Motor Retainer Upgrade Notice

BARRACUDA Kit

REVISED LOCATION GUIDE

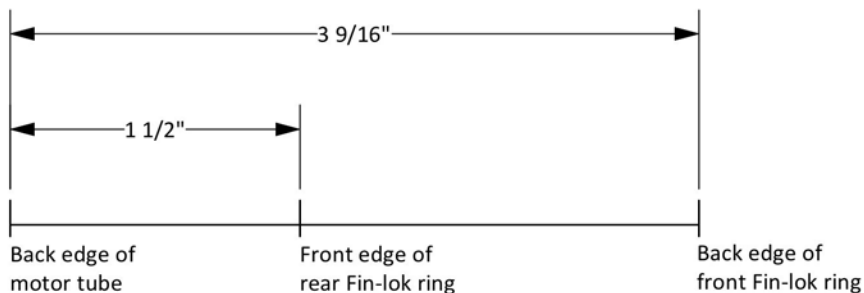
Use the LOCATION GUIDE above to make pencil marks along the motor tube line for location of the FIN-LOK rings per STEP 3. The new marks will move the motor tube rearward so that it is flush with the end of the body tube.

Follow Step 1 of FIN-LOK ASSEMBLY using new location marks as above.
